SUBJECT: TURKEY POINT UNITS 3 AND 4 - ISSUANCE OF AMENDMENTS RE:
RADIOLOGICAL EFFLUENT RELEASES - 10 CFR 20 REQUIREMENTS
(TAC NOS. M87043 AND M87044)

AMENDMENT NO. 157 TO FACILITY OPERATING LICENSE NO. DPR-31-TURKEY POINT UNIT 3
AMENDMENT NO. 151 TO FACILITY OPERATING LICENSE NO. DPR-41-TURKEY POINT UNIT 4

ATTACHMENT TO LICENSE AMENDMENT

FIGURE 5.1-1 SITE AREA MAP

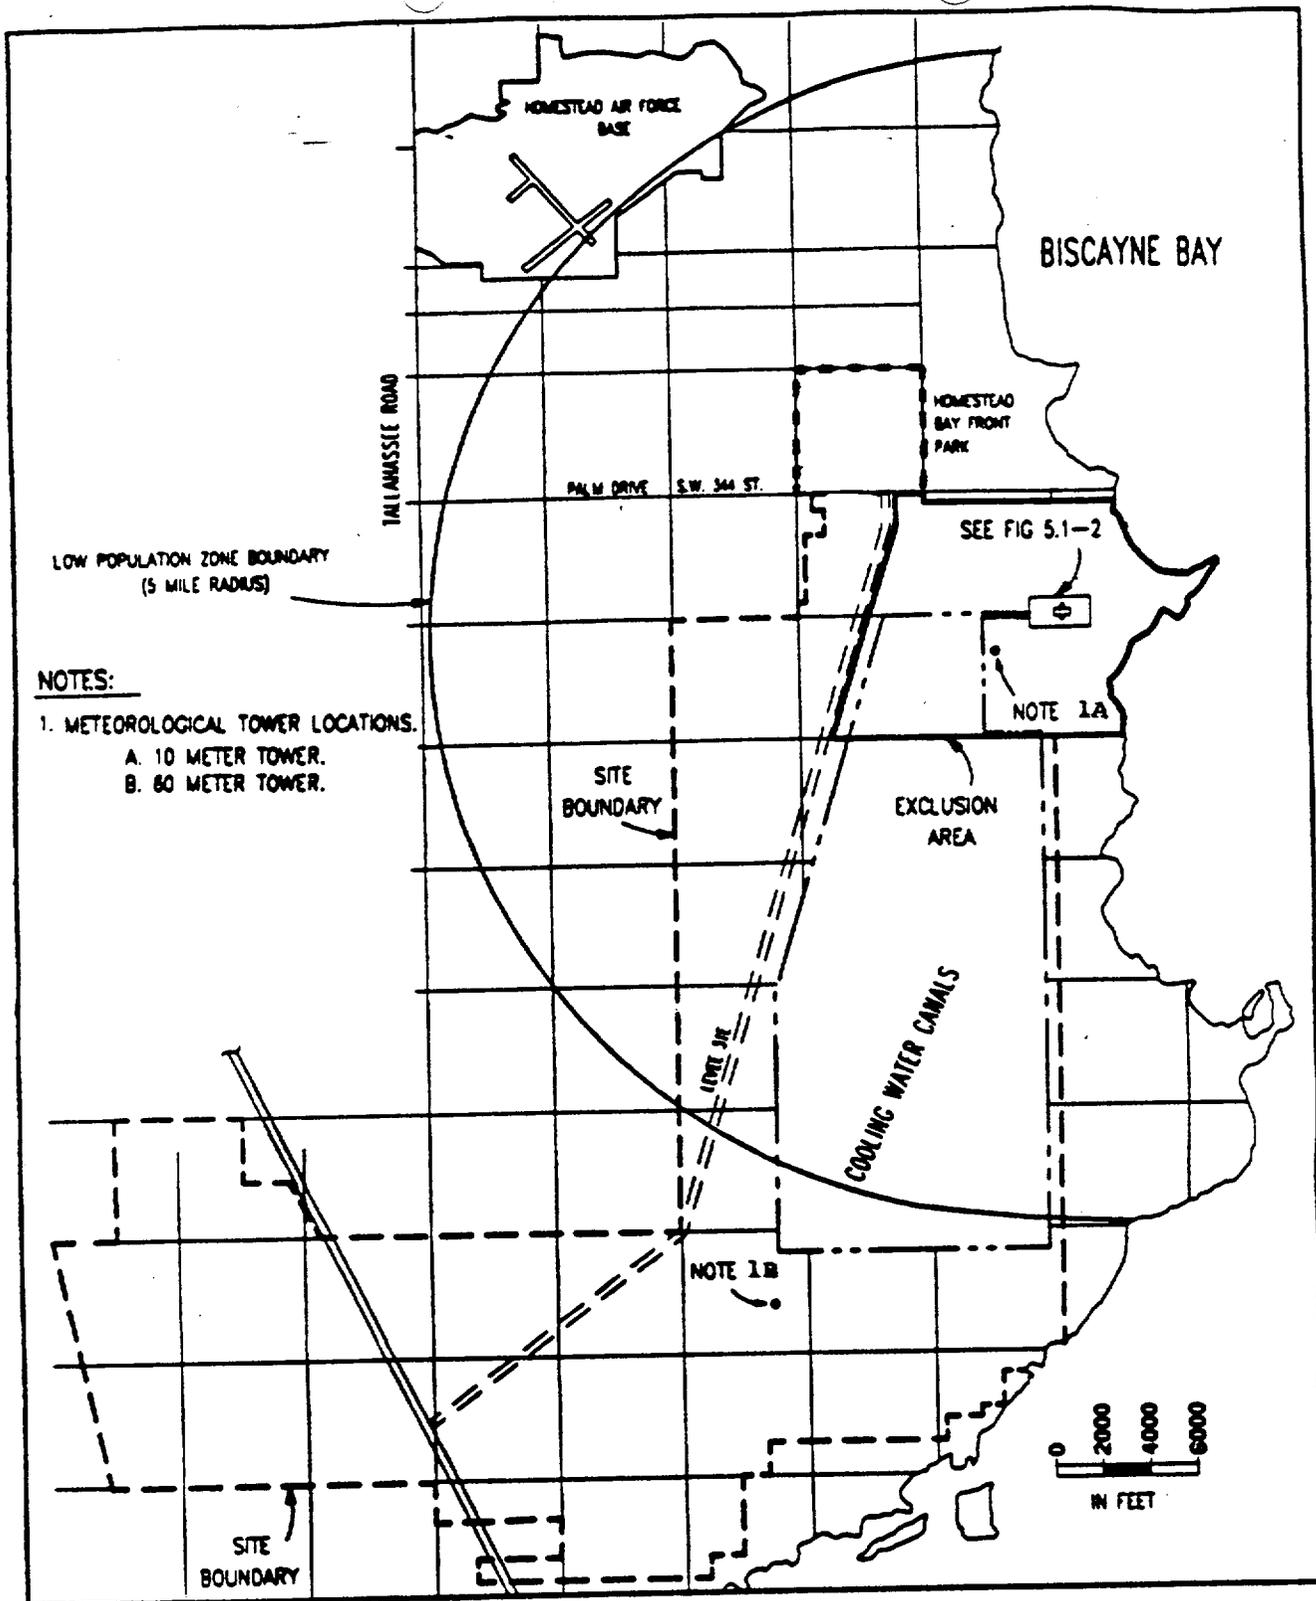
The licensee has proposed to delete Note 1 and the reference to the note. Additionally, the site boundary is being revised to reflect additional land owned by the licensee.

The areas referred to in Note 1 are no longer considered UNRESTRICTED AREAS as defined in the revised 10 CFR Part 20. The changes to the site boundary reflect land to the north and south owned by the licensee.

The changes are administrative in nature and are in agreement with the revised 10 CFR Part 20. The changes are acceptable.
